RENESAS TECHNICAL UPDATE

Product Category	MPU/MCU		Document No.	TN-RZ*-A0065A/E	Rev.	1.00
Title	Note on reconnecting the RZ/A2M USB2.0 host device to the peer-device		Information Category	Technical Notification		
Applicable Product	RZ/A2M Group	Lot No.	Reference Document	RZ/A2M Group User's Manual: Hardware Rev.3.00 (R01UH0746EJ0300)		
		All

This document is a cautionary note regarding reconnecting to the peer-device for the USB2.0 host device in products of the RZ/A2M Groups.

Flow1

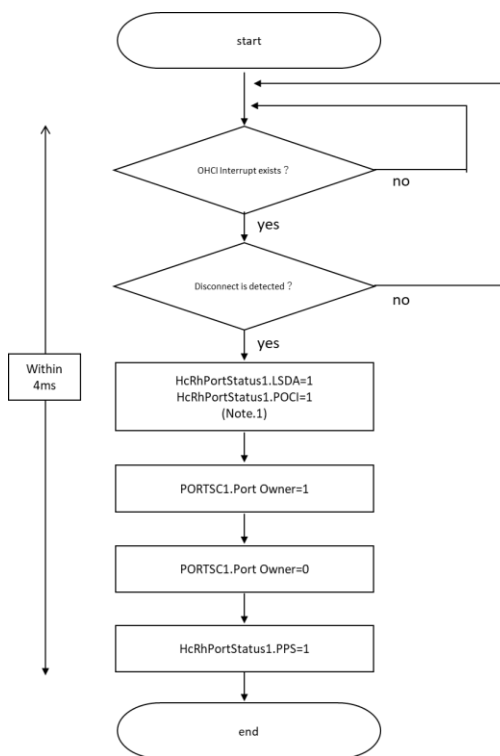
- 1) If peer-device is connected at Full Speed or Low Speed and a device disconnection occurs just before the frame boundary, subsequent peer-device connection may not be recognized.
- 2) If peer-device is connected at Full Speed or Low Speed and executes OHCI suspend instruction after disconnection of the device, subsequent peer-device connection may not be recognized.

If device disconnection occurs just before the frame boundary, or executes OHCI suspend instruction after disconnection of the device, Check the NPS and the PSM of the HcRhDescriptorA register, and the PPCM[1] of the HcRhDescriptorB register. Execute the flow according to the register value.
